Highway Statement

Demolition of existing dwelling and erection of replacement dwelling

Tanyffordd
Ruthin Road
Bwlchgwyn
LL11 5UU

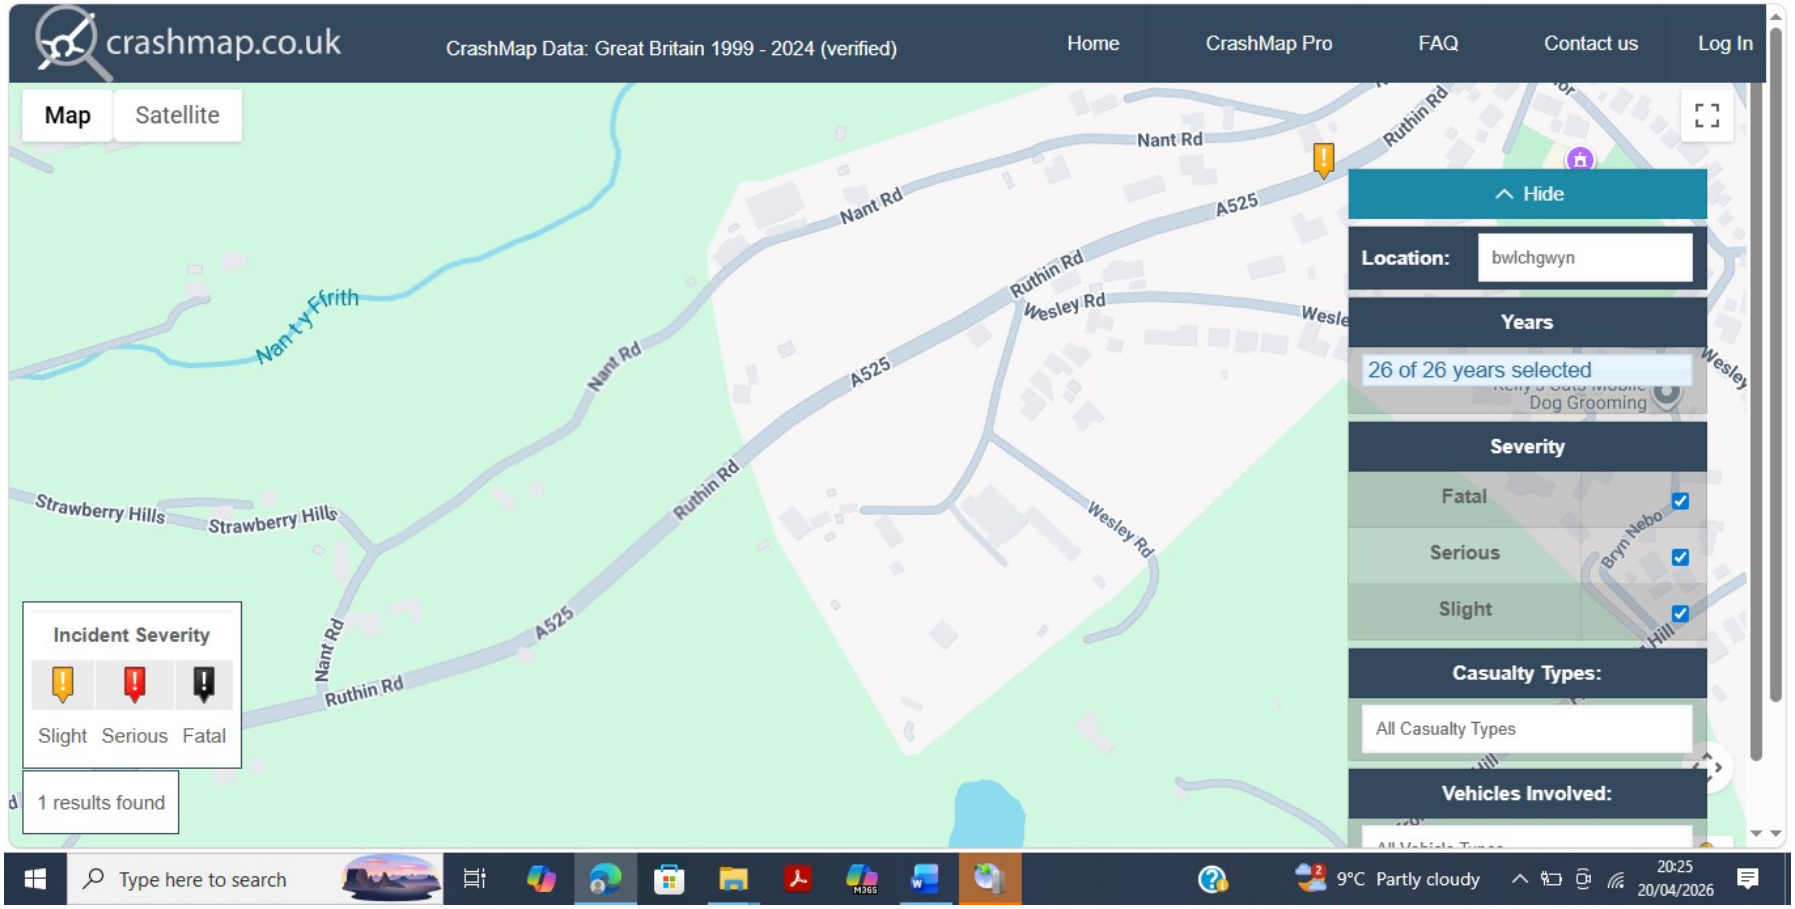
- Access for emergency vehicles

- Access Improvements

The plan submitted alongside this statement includes a number of swept paths of an ambulance entering and exiting the site.

It can be clearly seen that there is no issue accessing or egressing the site from / to the east. There is plenty of room within the site to turn without impacting on the proposed parking areas.

However, vehicles entering or exiting the site from / to the west have to undertake a three-point turn to manoeuvre into and out of the access. This is not a manoeuvre anyone using the access performs – it is simply included for completeness.

Vehicles approaching from the west have historically driven 100m past the access and turned round at the Wesley Road junction in order to approach the site access from the east. Similarly, those heading toward the west, drive east towards Wesley Road and then turn to leave in a westerly direction.
Although not ideal this is how the site has operated for decades without any recorded highway issues.

The access will be surfaced in a bound material for a minimum of 10m back from the edge of highway; this will be of significant benefit to highway safety and manoeuvrability both into and out of the site.

There is no scope to widen the access due to the gradient of the adjoining land.

A parking and turning area will be provided to the front to the replacement dwelling. The turning area will be of significant benefit to highway safety and ensure that there is adequate space provided for all vehicles including ambulances to enter and exit the site in a forward gear.
